Telecommunications System Construction Contract and Specifications; RUS Standards for Service Installations at Customer Access Locations; Final Rules

Telecommunications System Construction Contract and Specifications

ACTION: Final rule.

FIGURE 3

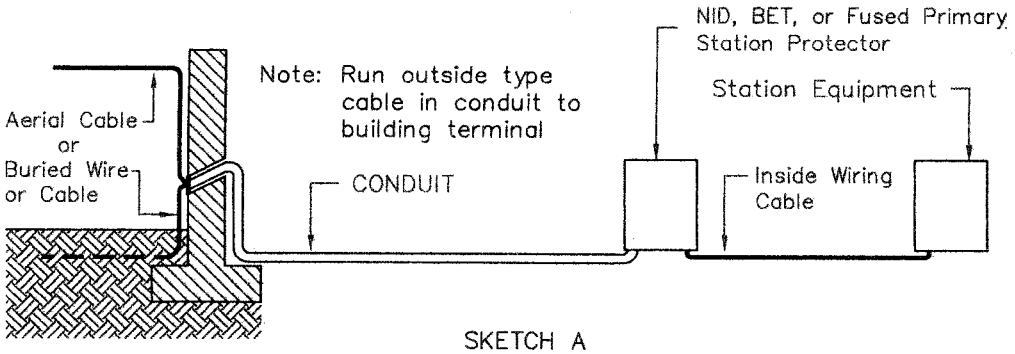
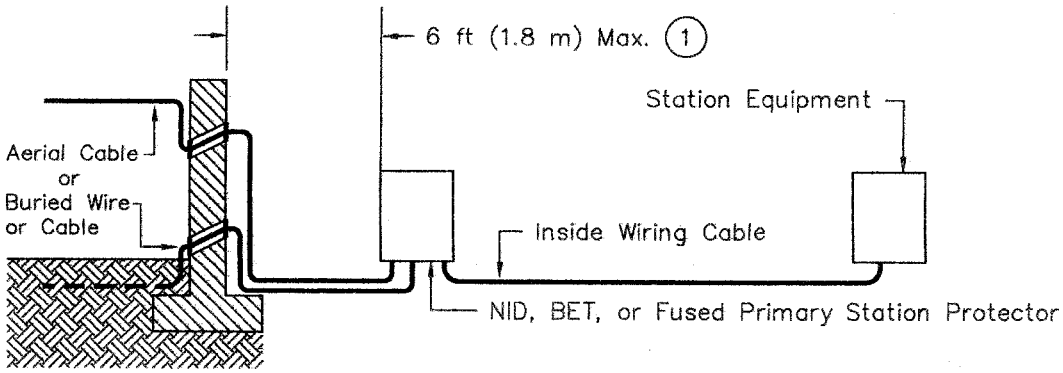
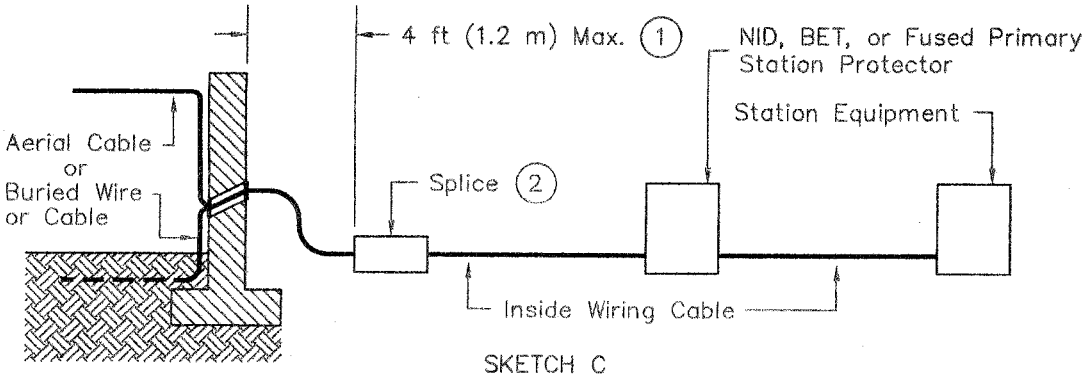
2. Figures 3 and 8 have been revised to reference the 1999 issue of the *NEC*® instead of the 1996 issue of the *NEC*®, which is no longer in effect.

FIGURE 9

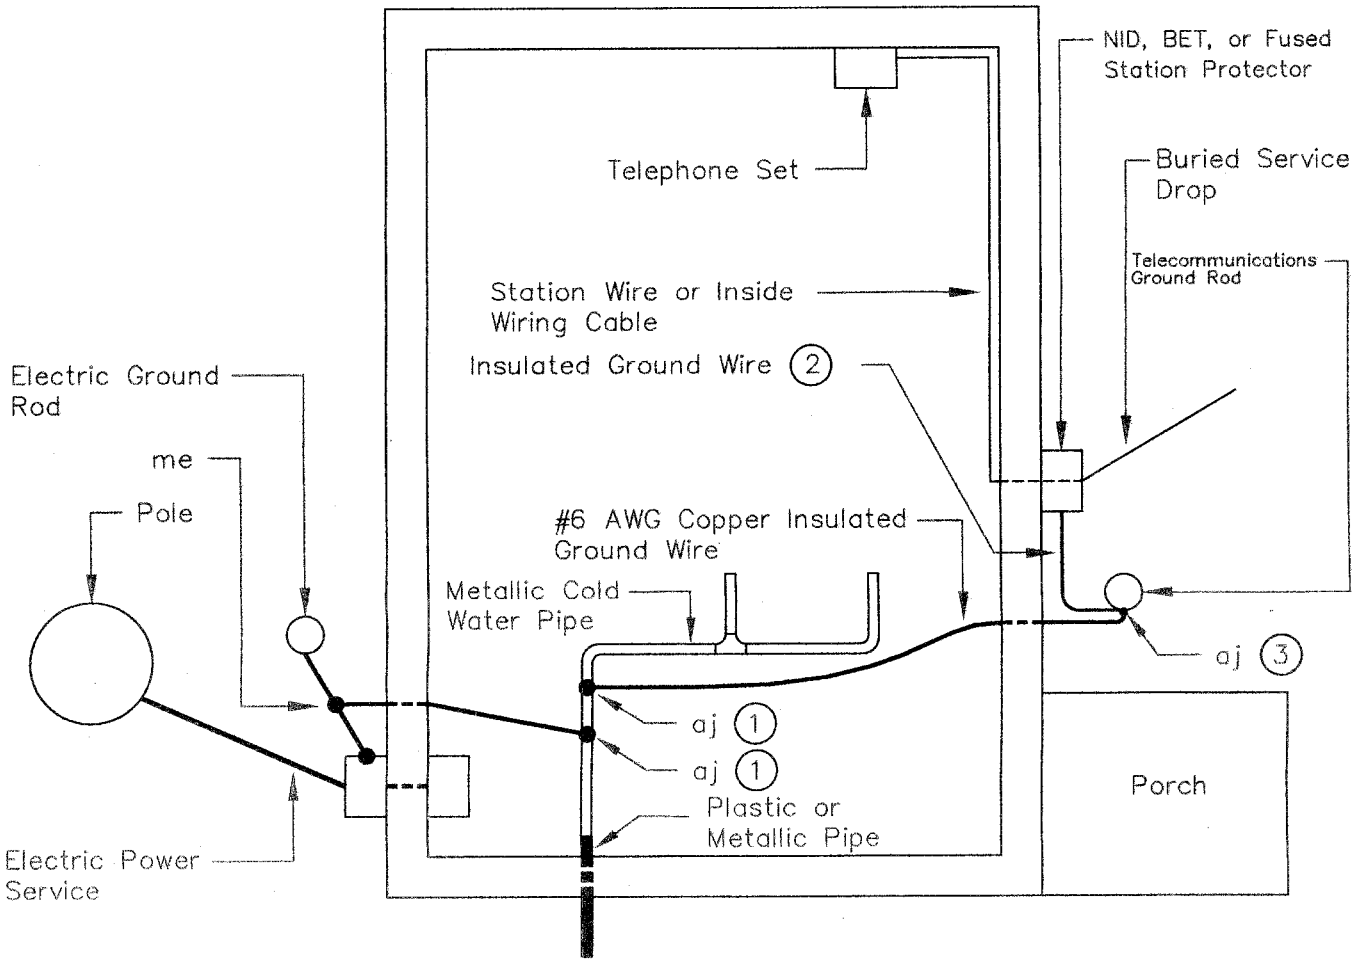
3. Figures 9, 17, and 18 have been revised to indicate generic telecommunications service wire installations at customer access locations instead of specific telecommunications service wire installations at customer access locations because it is impossible for RUS to predict the number of telecommunications service circuits requested by customers. This was accomplished by replacing the references to the ''#12 AWG copper insulated ground wires'' which specify only two pair telecommunications services with generic references to ''copper insulated ground wires'' and ''associated notes'' indicating that § 1755.508(v), Table 5, should be used to determine the correct ground wire conductor size suitable for the installations based on the number of telecommunications circuits installed at customer access locations.

BM50

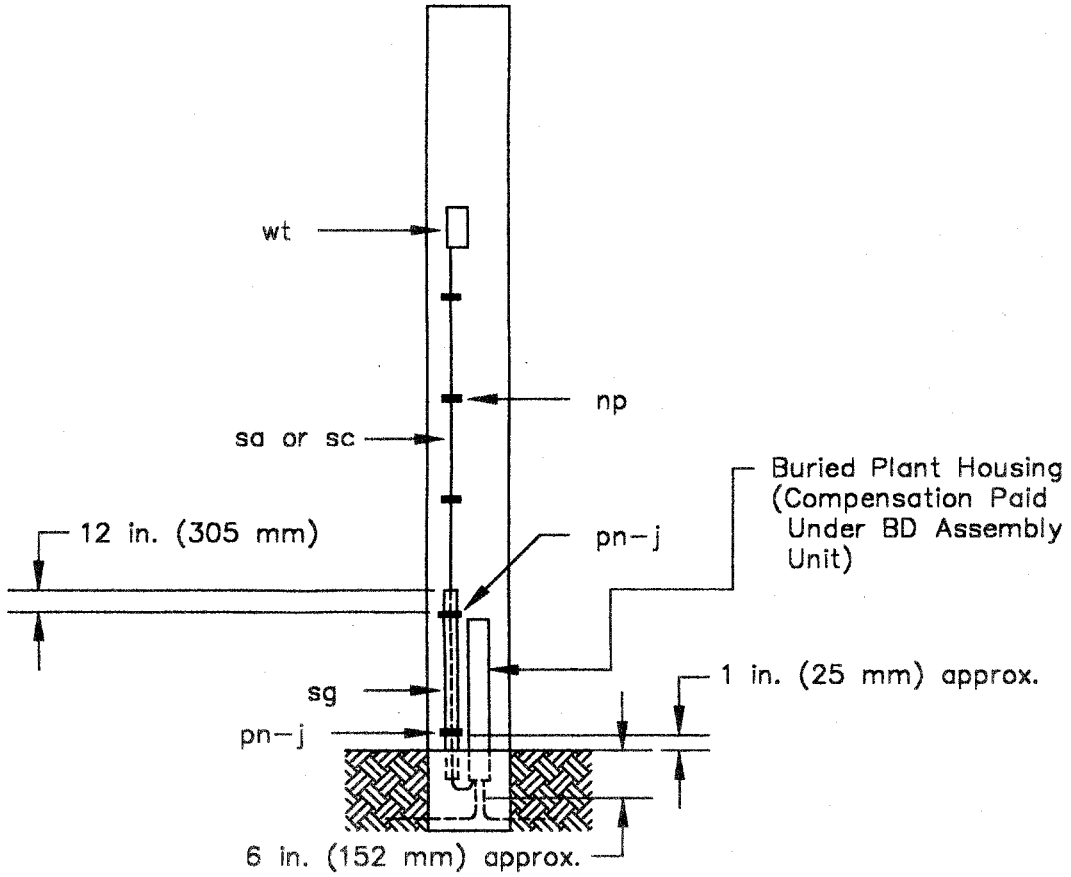
7. The ''BM50 Assembly Unit Drawing'' is being inserted to replace Construction Drawing 912 in § 1755.510. The reason for this change is attributed to current installation practices. Aerial service wires (from buried cables) are installed in accordance with information provided in the BM50 Assembly Unit Drawing not the 912 Construction Drawing. The major difference between the BM50 Assembly Unit Drawing and the 912 Construction Drawing is that the BM50 drawing eliminates the aerial service installation information from the drawing and indicates that the buried plant housing is paid under the buried plant housing assembly unit (BD).

BM83

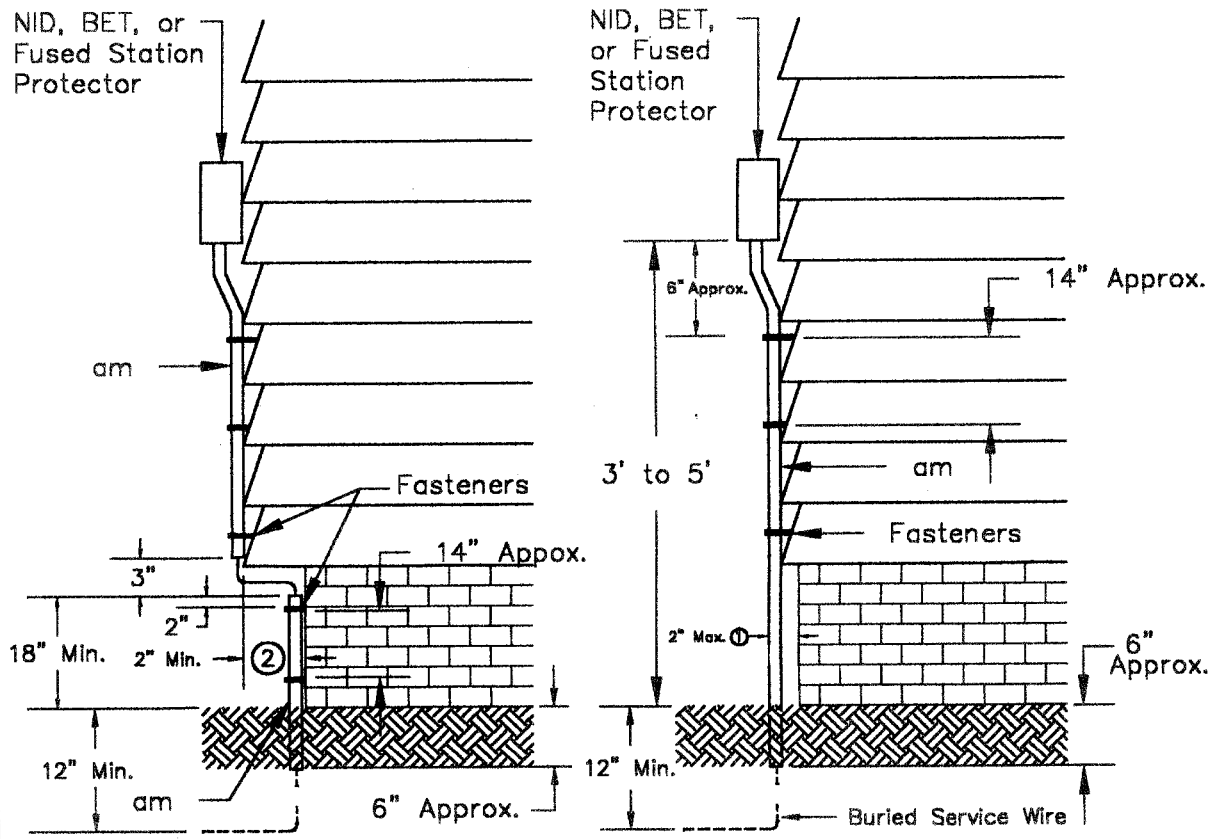
minimum of 24 in. (610 mm) specified in § 1755.505(e)(3) to a minimum of 12 in. (305 mm). The language in § 1755.505(e)(3) will now read as follows: ''Buried service wire or cable shall be placed to a depth of 12 in. (305 mm) or greater where practicable in soil, 36 in. (914 mm) in ditches, or 3 in. (76 mm) in rock. Depths shall be measured from the top of the wire or cable to the surface of the ground or rock.'' In addition, the BM83 Assembly Unit and 962 Construction Drawings in 7 CFR § 1755.510 is being revised to indicate that the minimum burial depth of buried service wire or cable at customer access locations will now be 12 in. (305 mm) in soil instead of 24 in. (610 mm). As result of RUS's change in the depth of buried service wire or cable in soil, the depth of the buried service guard in soil is being changed from 12 in. (305 mm) to 6 in. (152 mm) in the BM83 Assembly Unit Drawing.

RURAL TELECOMMUNICATIONS CONSTRUCTION PRACTICES AERIAL PLASTIC CABLE DETAILS OF WIRE CONNECTIONS TO FILLED TERMINAL BLOCKS	
	Scale: NTS	March 2001
		312–1

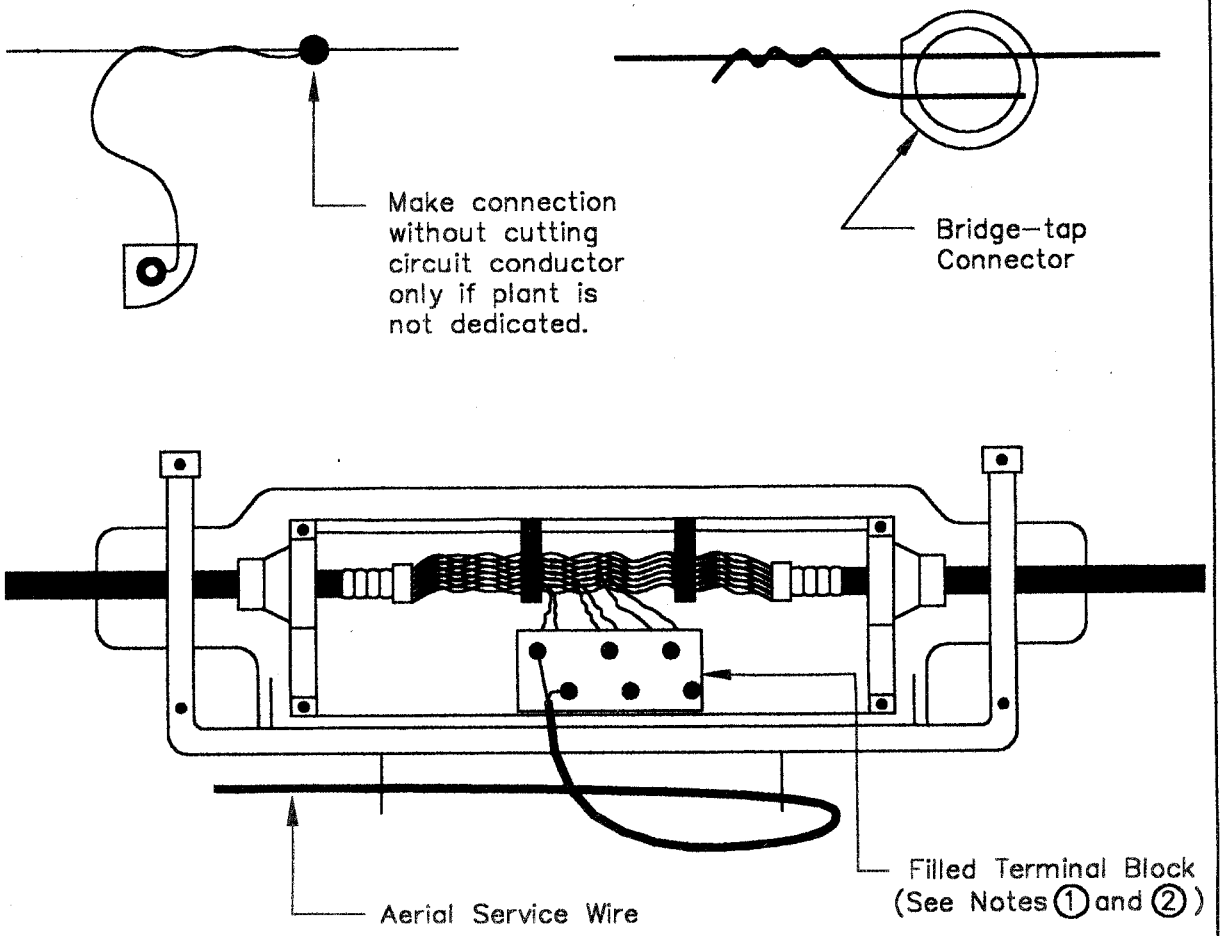
The final comment from the same respondent questioned the editorial and technical correctness of Construction Drawings 312–1, 501–1, 501–2, 702, 958, and 962 in § 1755.510.

4. Construction Drawing 312–1 in § 1755.510 is being changed by adding the respondent's recommended language of ''only if plant is not dedicated'' to the proposed language concerning one of the methods of terminating the lead-out wires of terminal blocks to distribution cable conductors. This new language will read as follows: ''Make connection without cutting circuit conductor only if plant is not dedicated.''

Scale: NTS		March 2001
		958

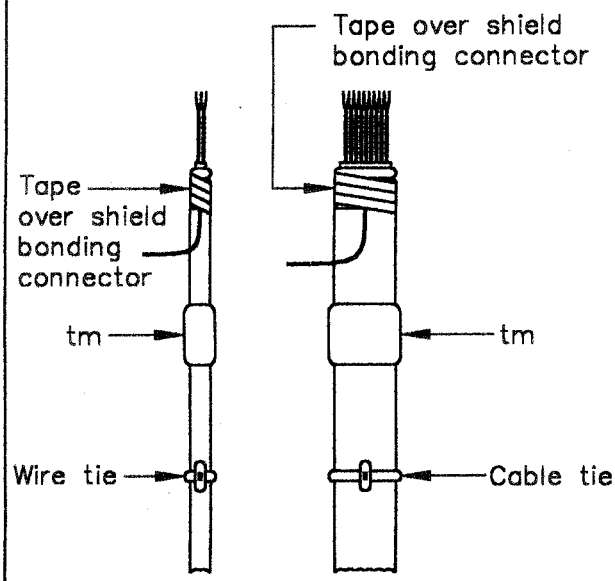
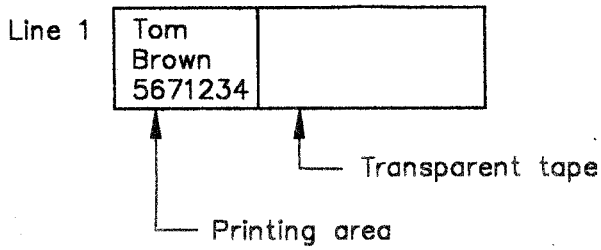
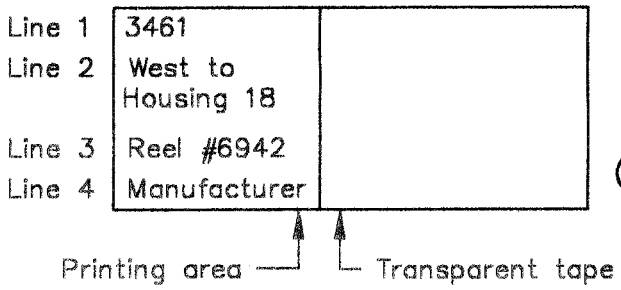
8. Note #4 of Construction Drawing 958 was modified to allow the use of alternative marking materials as requested by the respondent.

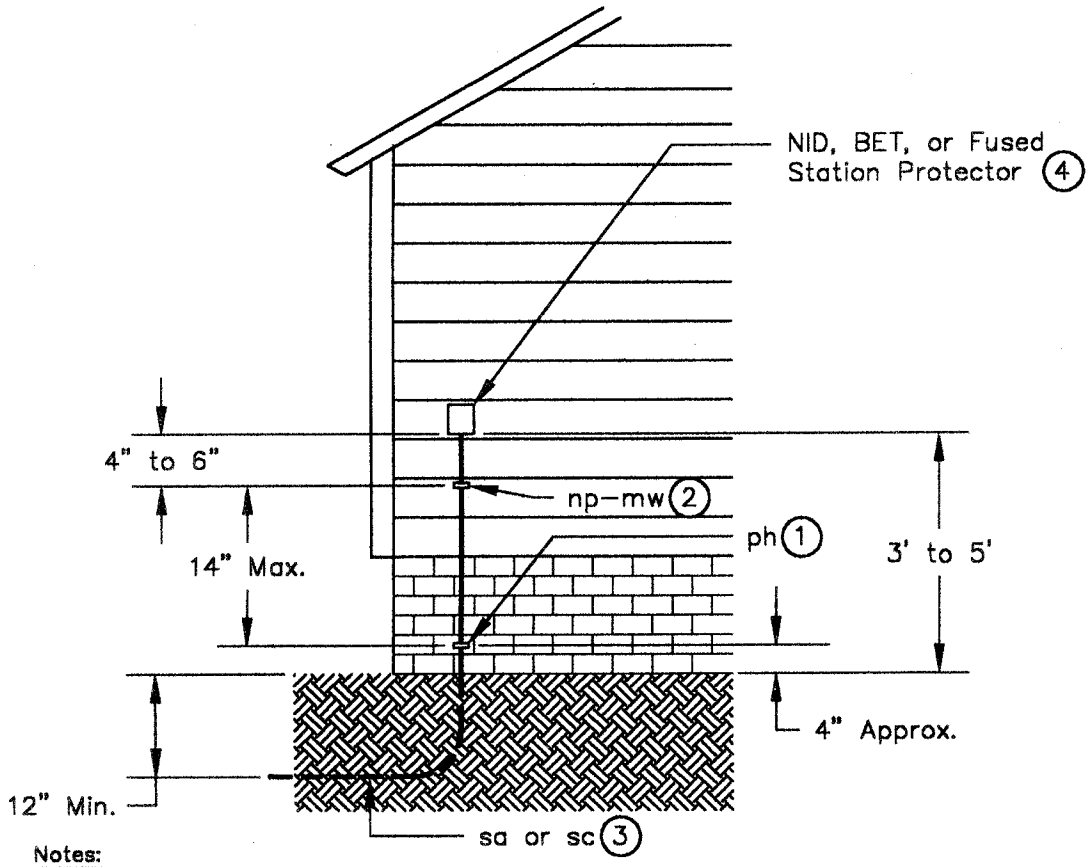
9. The respondent questioned the wisdom of placing the ground wire and service wire under the same attachment device when parallel runs are encountered as indicated in Note #2 of Construction Drawing 962 in § 1755.510. After much discussion and consideration concerning this procedure, RUS is not modifying the proposed Note #2 language of Construction Drawing 962 in § 1755.510 because the allowance of this installation procedure over the past 15 years has not resulted in any service problems at customer access locations.
